# Access Compliance Report

## Public Rights-of-Way

### (Curb Ramps)

Intersection ID: 16388	Main Street: BILLINGSLEY_RD	Cross Street: CASCADE_CR	Location: SW
ADA ID: D46E72BC5E50	Ramp Type: PerpDiag	Initial Pass/Fail: Fail	Overall Compliance: No
			Severity Score: 31.25

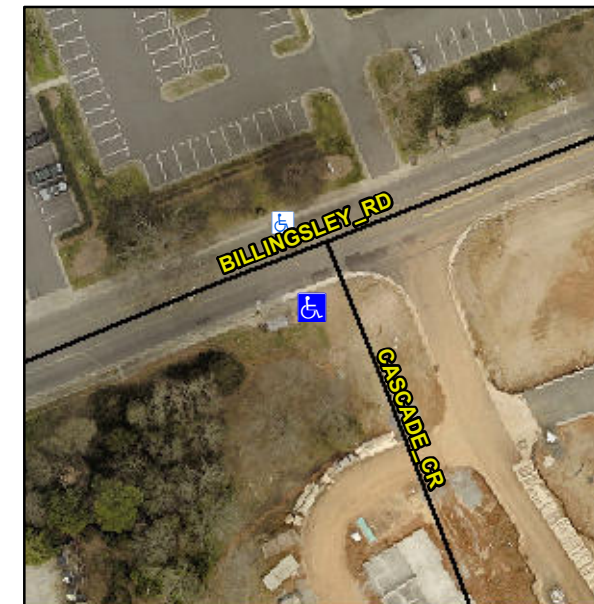
**Not Found, R304.5.1, R304.2.2, R304.5.3**

Compliance	Description	Data	Compliance	Description	Data
N/A	Ramp Length (in)	60.0	No	Ramp Slope (%)	8.6
No	Ramp Width (in)	33.0	No	Ramp XSlope (%)	3.5
N/A	Flare Type LT	N/A	N/A	Flare Type RT	N/A
N/A	Flare Slope LT (%)	N/A	N/A	Flare Slope RT (%)	N/A
N/A	Flare Traversable LT?	N/A	N/A	Flare Traversable RT?	N/A
N/A	Landing Length (in)	N/A	N/A	DWS Provided?	N/A
N/A	Landing Width (in)	N/A	N/A	DWS Contrast?	N/A
N/A	Landing Slope (%)	N/A	N/A	DWS Length (in)	N/A
N/A	Landing X Slope (%)	N/A	N/A	DWS Full Width?	N/A
N/A	Landing Curb? (Y/N)	N/A	N/A	DWS Offset (in)	N/A
N/A	Shared Landing?	N/A			
N/A	Gutter Ponding?	N/A	N/A	Gutter Slope (%)	N/A
N/A	Gutter Lip Ht (in)	N/A	N/A	Gutter X Slope (%)	N/A
N/A	Painted X Walk1?	No	N/A	Painted X Walk2?	No
	X Walk 1 Direction	To E		X Walk 2 Direction	To N
N/A	X Walk 1 Width (in)	N/A	N/A	X Walk 2 Width (in)	N/A
	X Walk 1 Slope (%)	1.7		X Walk 2 Slope (%)	5.9
	X Walk 1 X Slope (%)	3.9		X Walk 2 X Slope (%)	2.9

**Remove & Replace Curb Ramp With Two New Directional Ramps or Equivalent.**
